ENVIRONMENTAL REVIEW TEAM REPORT

HICKORY RIDGE SUBDIVISION NORFOLK, CONNECTICUT

Norfolk Planning and Zoning Commission

FEBRUARY 1987

**CONCEPTUAL
SITE PLAN**

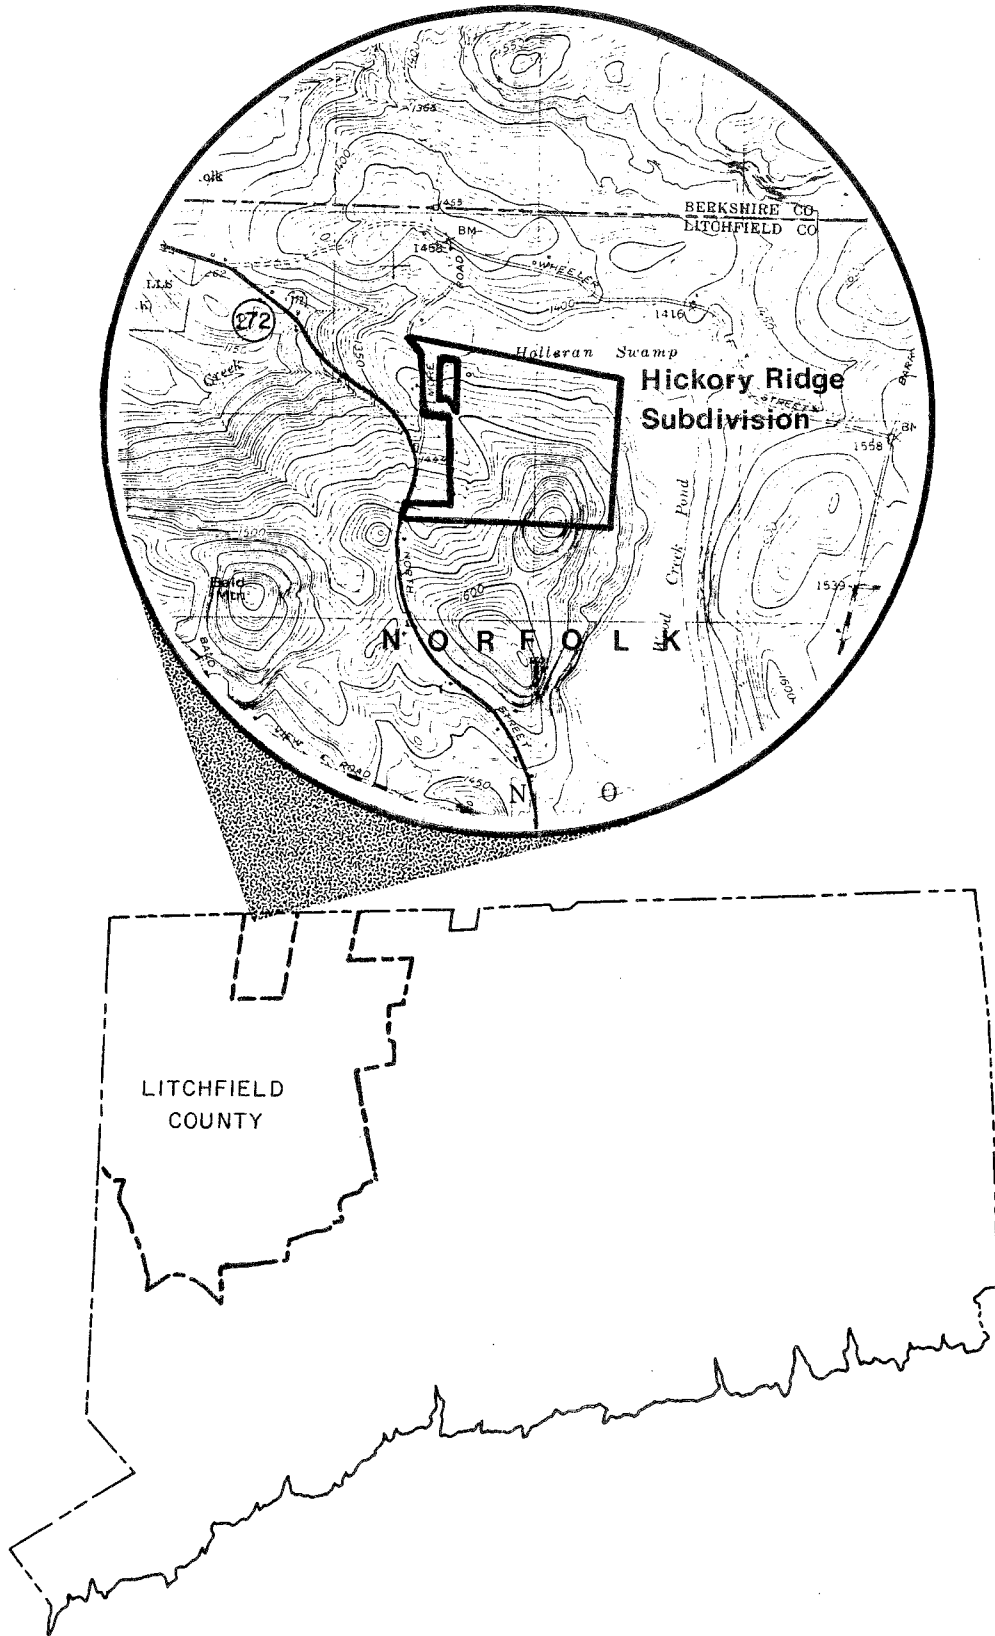
As shown on the proposed plan, there is altogether too much road. The length of road can be reduced by the use of at least one cul-de-sac (Figure 9).

WATERSHED BOUNDARY

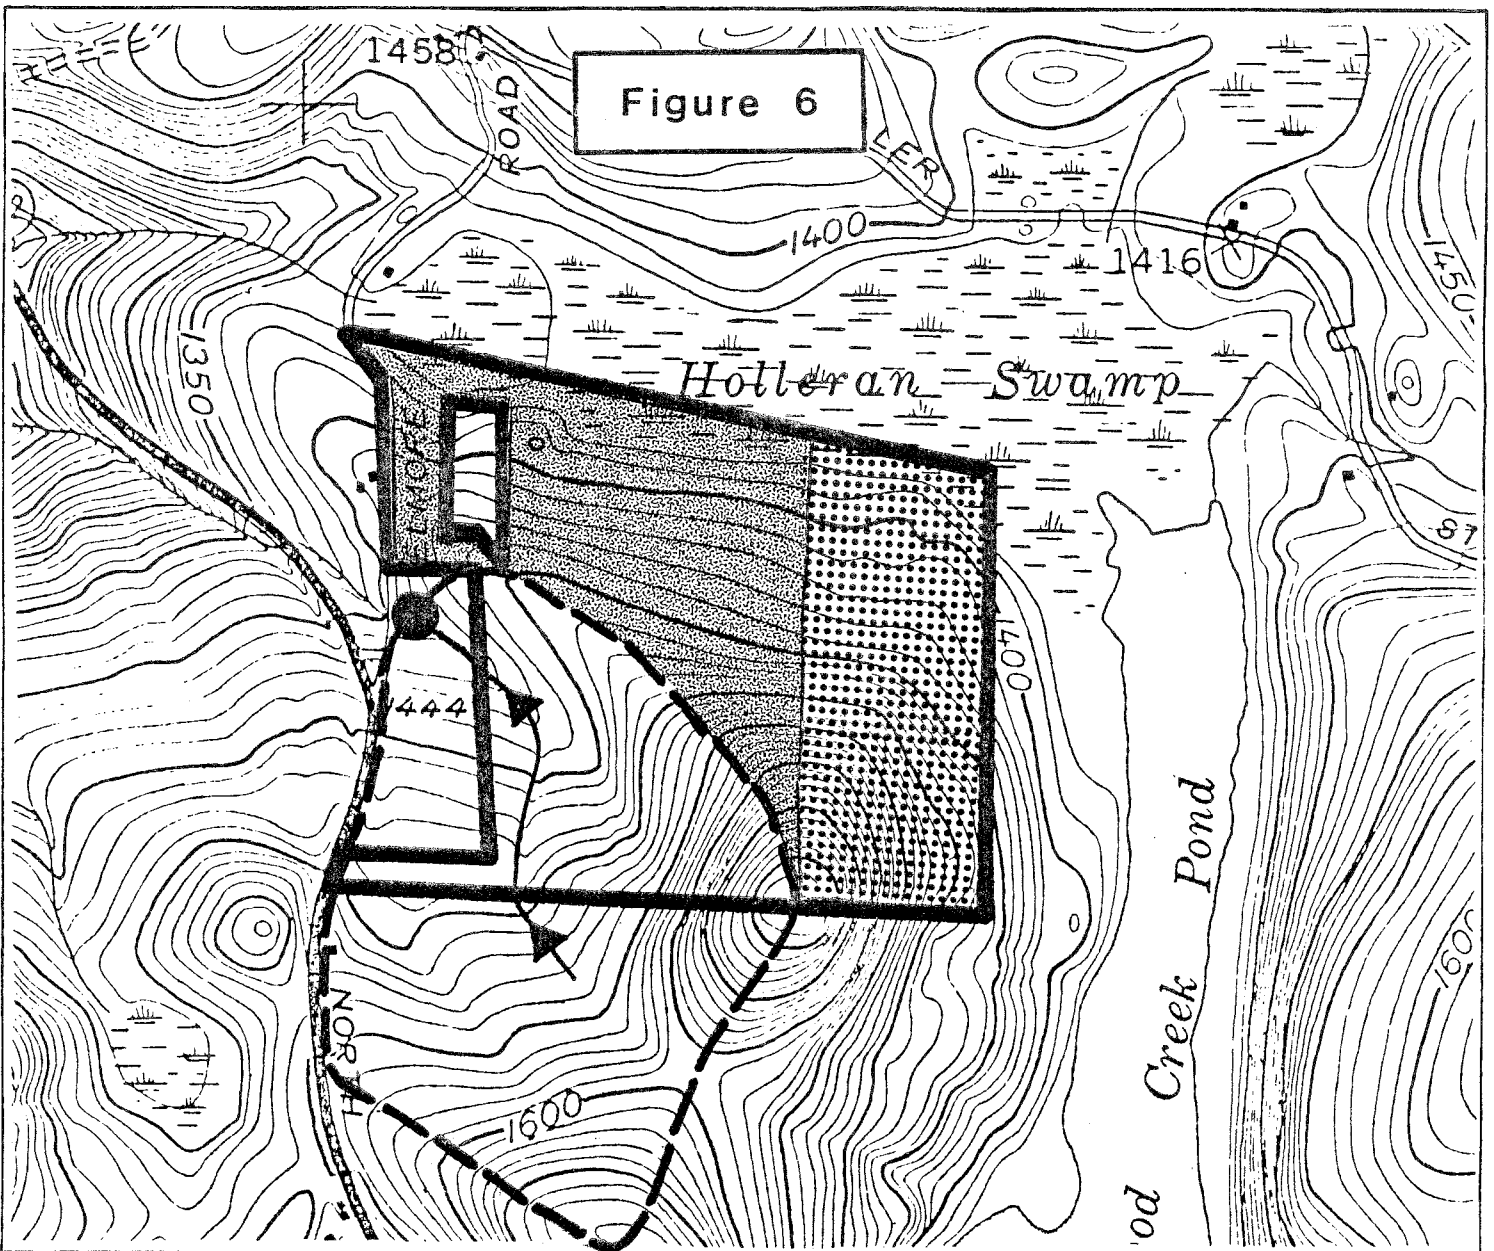
It is suggested that the developer inspect the size of the culvert under Elmore Road since it receives drainage from the southwest corner of the site. Because of the moderate to steep slopes above Elmore Road, there is little opportunity for natural detention that is performed by Holleran Swamp and Wood Creek Pond. As a result, even a small increase in runoff in this area could lead to flooding problems if the culvert is too small.

Surface runoff within the parcel can be divided roughly into three subdrainage areas (Figure 6). Except for about 60 acres in the eastern limits, encompassing proposed Lots 7 to 9, surface runoff from the site is routed via the major watercourse in the western parts to Ginger Creek. Lots 7 to 9 drain downslope to Wood Creek Pond.
